CORRIGENDUM- 02

PROJECTs	:	2 X 800 MW NTPC LARA TPP STAGE-II
PACKAGE	:	COOLING TOWER - Induced Draft Cooling Towers (IDCT)
ENQUIRY NO	:	PE/PG/LAR/E-7421/2023 Dated-1-Mar-24
SUBJECT	:	CHANGE OF TENDER ID + PRE-BID CLARIFICATION + DUE DATE EXTENSION

TITLE: TOPOGRAPHICAL SURVEY
 (S.D. SURVEY DATA FOR NCL PURPOSE)

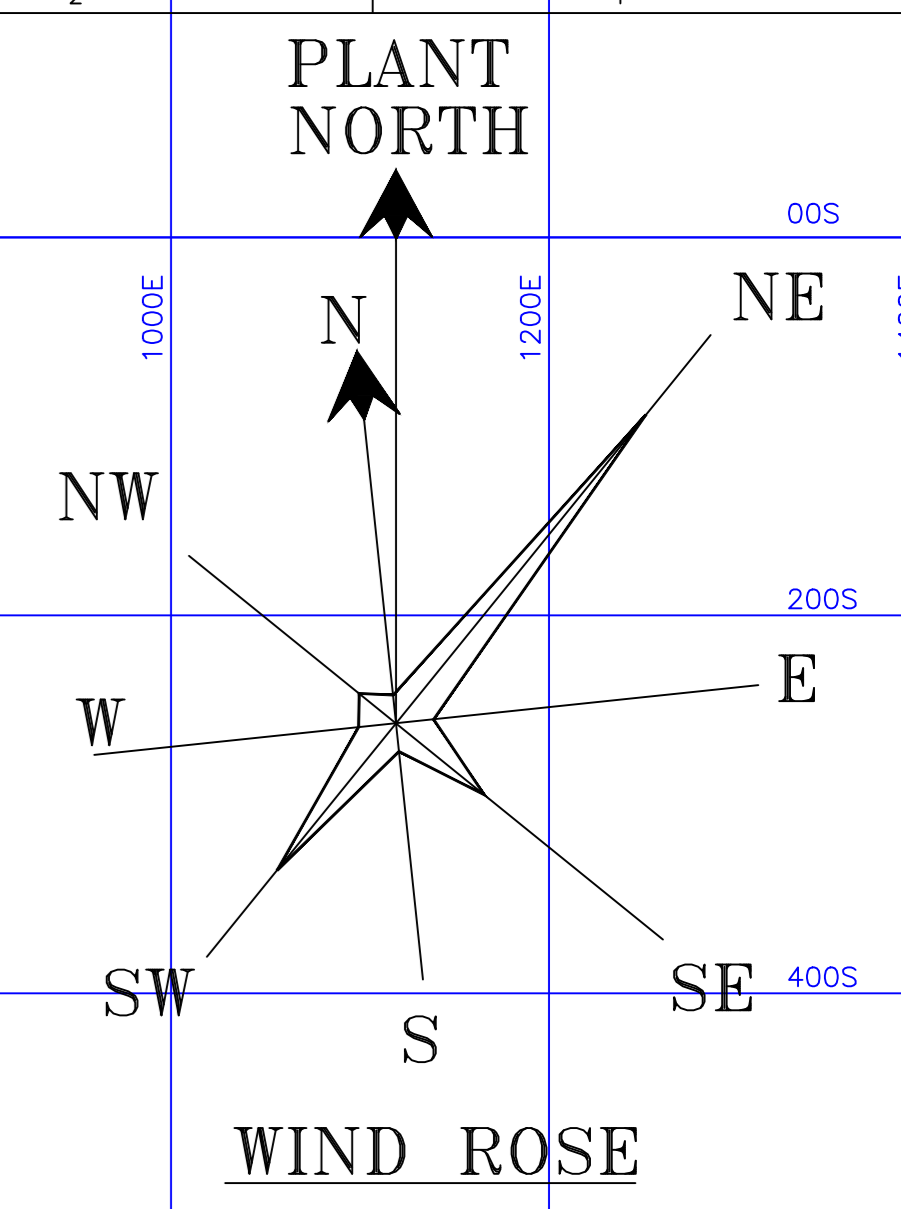
3.0 Topographical Survey drg (Sheet 1 and sheet 2) is attached.
